Project No. 21482114

**RESPONSE TO GEOTECHNICAL PEER REVIEW COMMENTS FROM GEMTEC
PROPOSED RESIDENTIAL DEVELOPMENT
3930 AND 3960 RIVERSIDE DRIVE, OTTAWA, ONTARIO**

A geotechnical peer review was completed by GEMTEC on behalf of the City of Ottawa and the relevant comments were provided in GEMTEC Letter no. 100008.025 – Rev0, dated Dec 7, 2023. The comments are noted below with response from WSP.

PROJECT NO. 21482114 CONTROL 0005 REV. 0 FIGURE 1

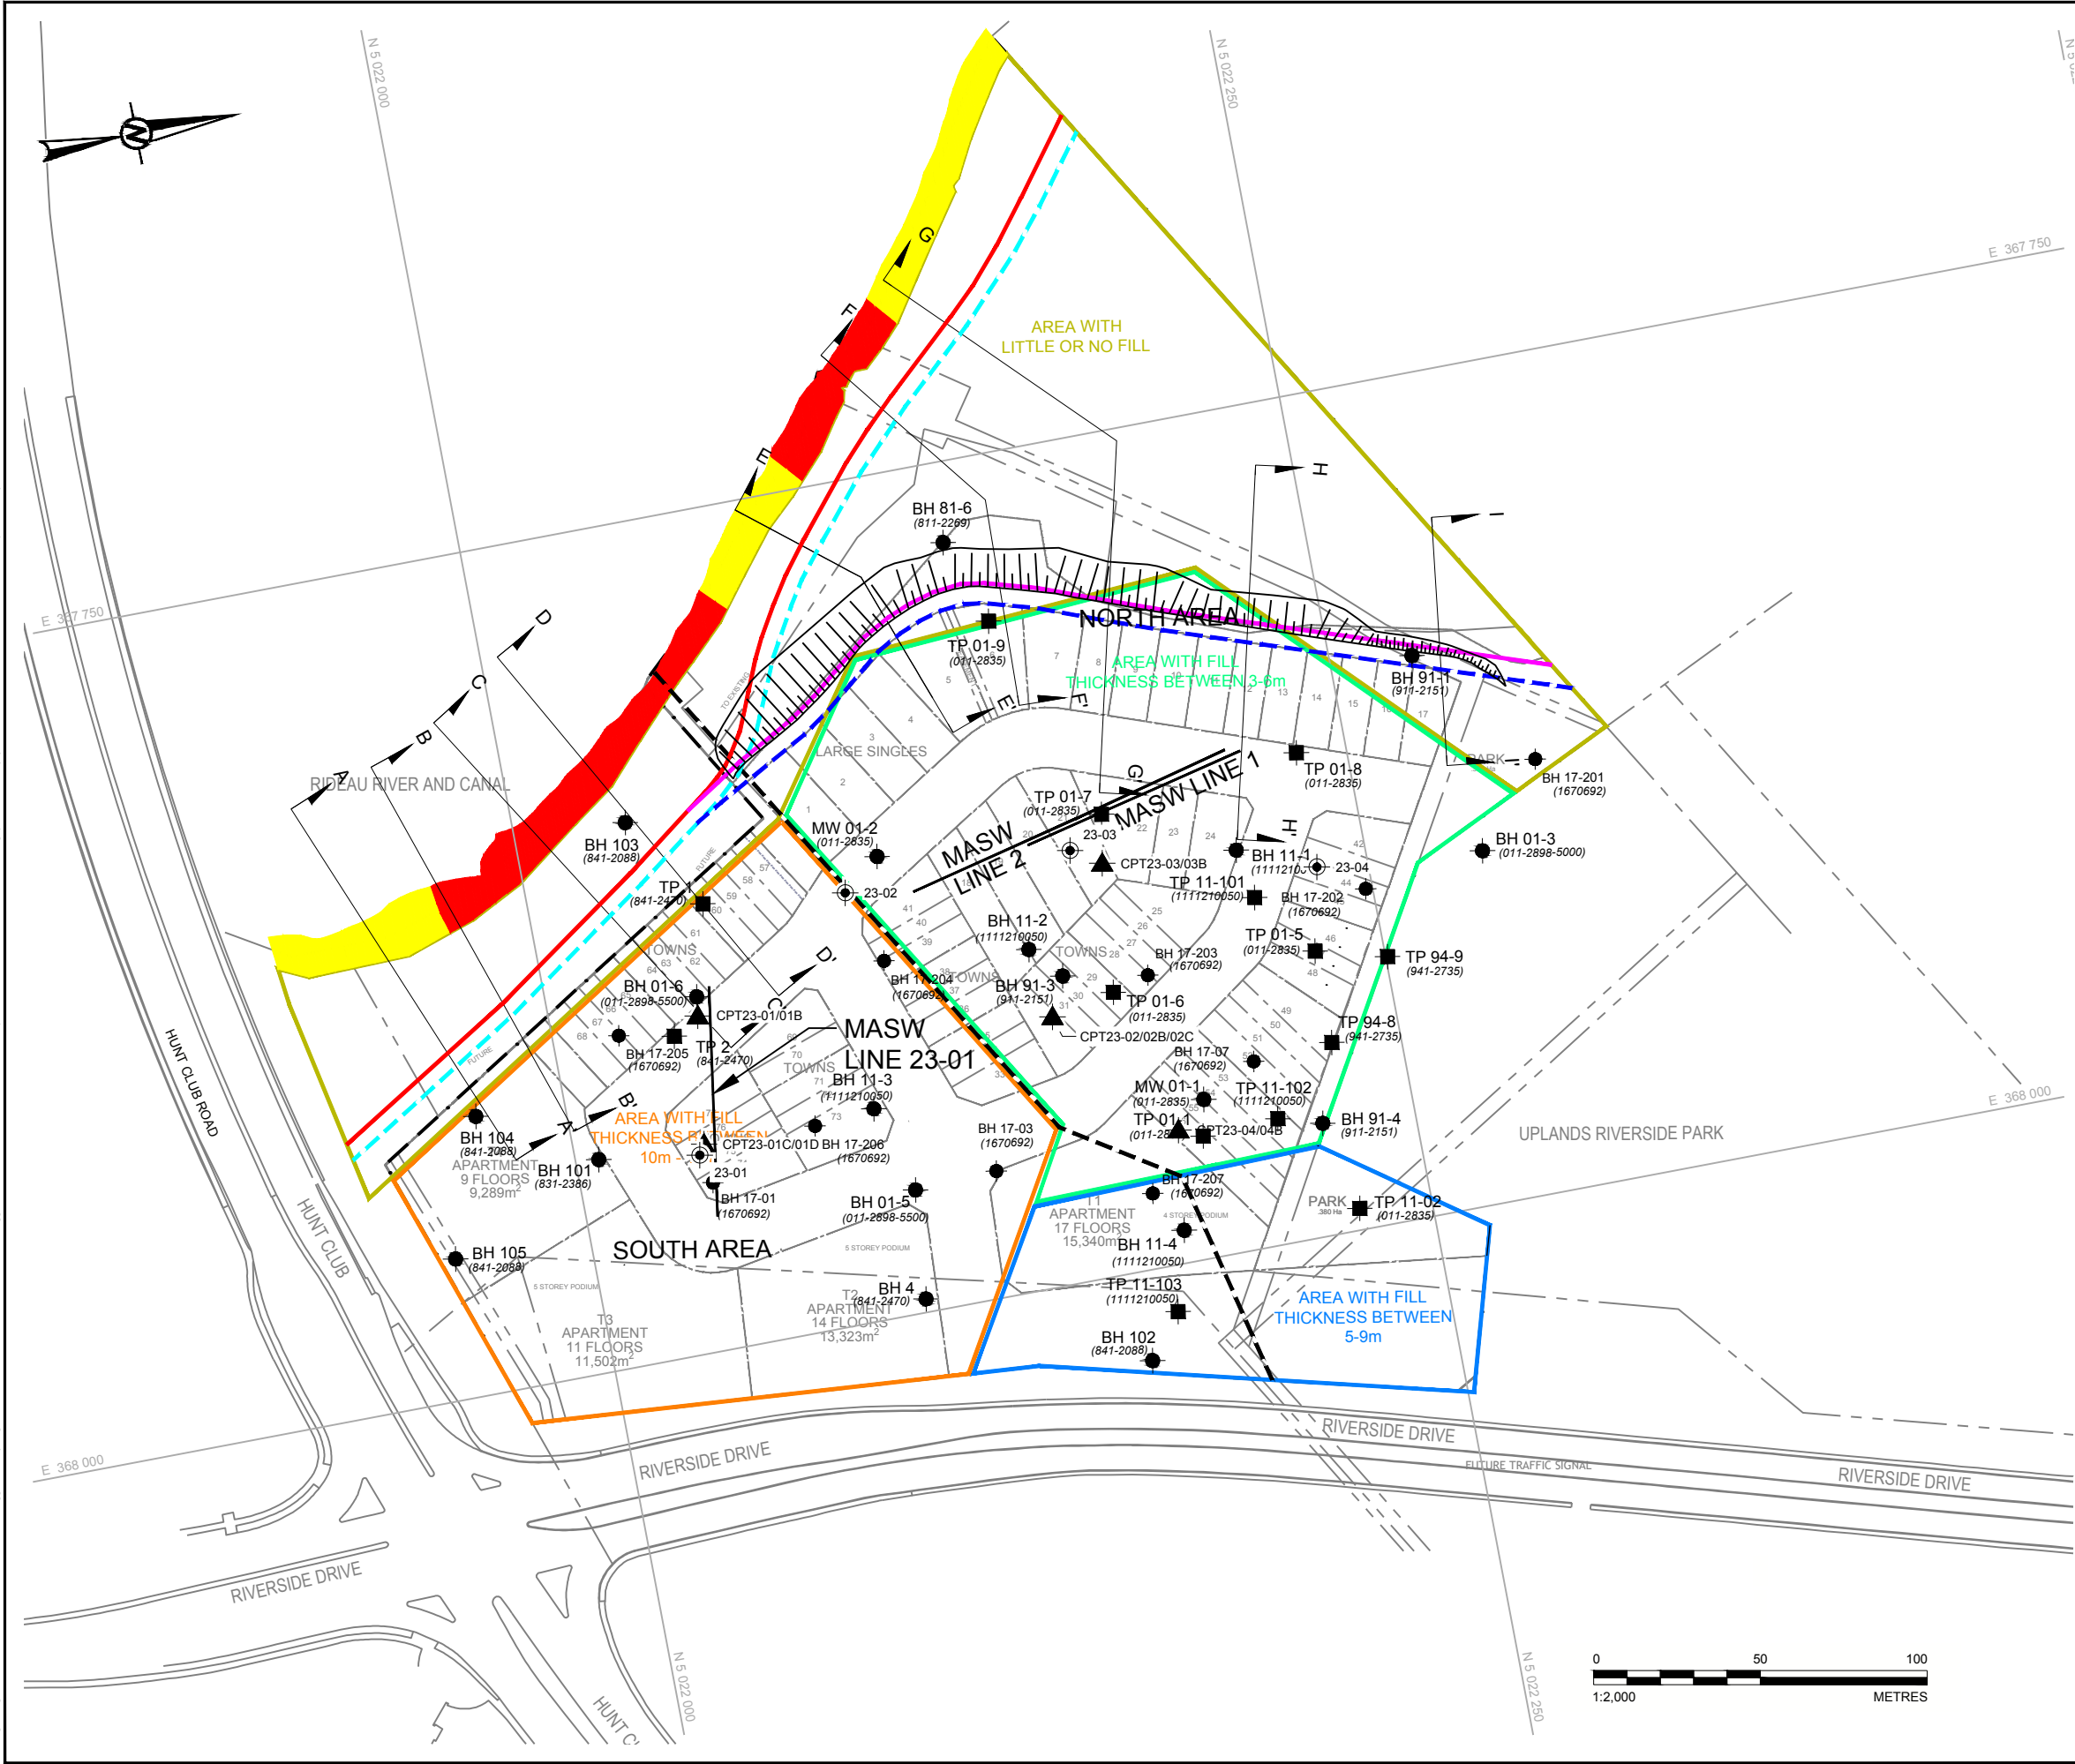
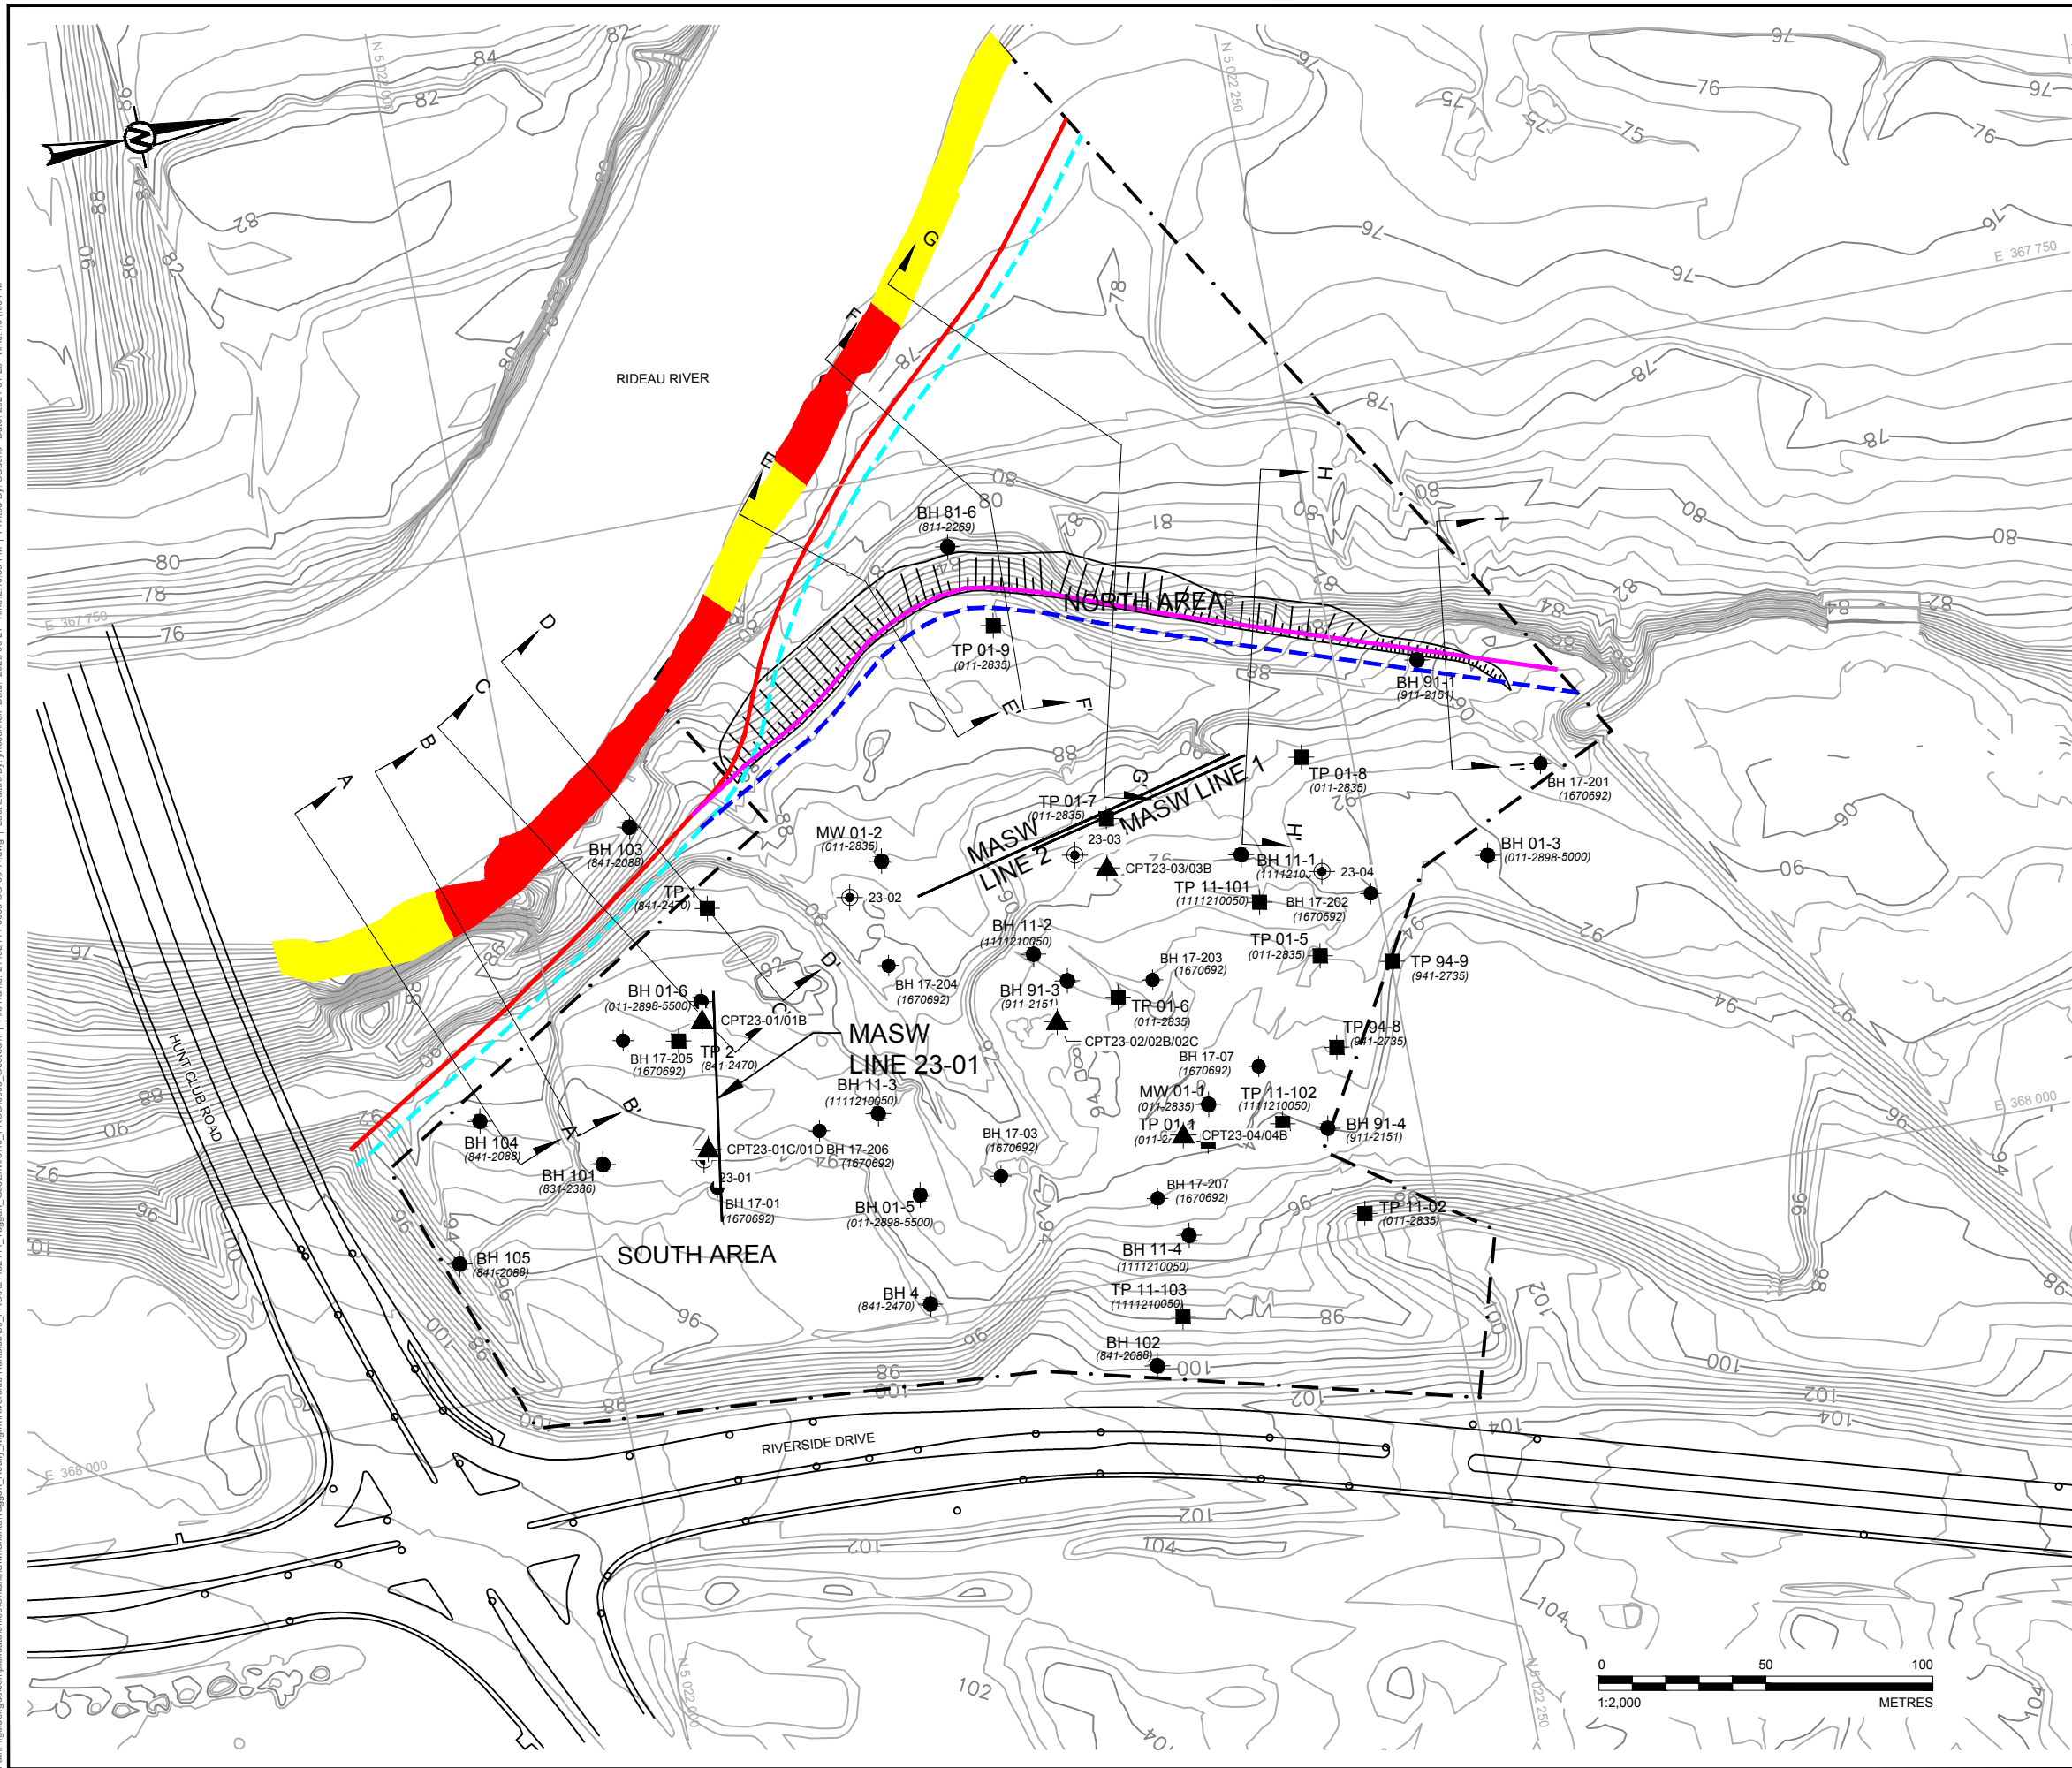
- 1) "The site plan in the report (i.e., Figure 1) indicates the locations for the following test pits or borehole but the records do not seem to be included in the report.
 - Testpits 1 to 17 (Project No. 011-2898);
 - Testpits 94-15 and 94-18 (Project No. 941-2135);
 - Testpits ST-1A, ST-1B, ST-1C, ST-2A, ST-2C (Project No. 1111210050); and,
 - Boreholes 3, 5, and 6 (Project No. 841-2470)"

- 2) "In addition, the following was also noted with respect to the testhole records and site plan:
 - TP 11-102 (011-2835) and TP 11-02 (1111210050) seem to be mis-labelled; and,
 - There appears to be an unlabelled testpit marker in the area between BH 91-3, CPT23-02/02B/02C, and 17-203 (approximately in the middle of the site)."

- 3) "The MASW testing was carried out within the North Area, where the fill thicknesses are significantly less than in the South Area (i.e., 6 to 7 metres at the MASW lines versus up to 20 m thickness in the South Area). Due to the significant difference in stratigraphy, it is not clear that the obtained shear wave velocity values are representative within the South Area or that the interpreted Site Class D based on those values is also applicable for the South Area. "

Response - *The above noted records could not be located in our archives and have therefore not been included in the report. The locations of these boreholes and test pits have also been removed from the site plan for clarity.*

Response - *The above has been corrected on the site plan.*

Response – *Additional MASW testing within the South Area was carried out by Conetec on 2 March 2023 (See Appendix G of the WSP report). The results are consistent with a Site Class D. This MASW line has now been added to the Site Plan (Figure 1).*
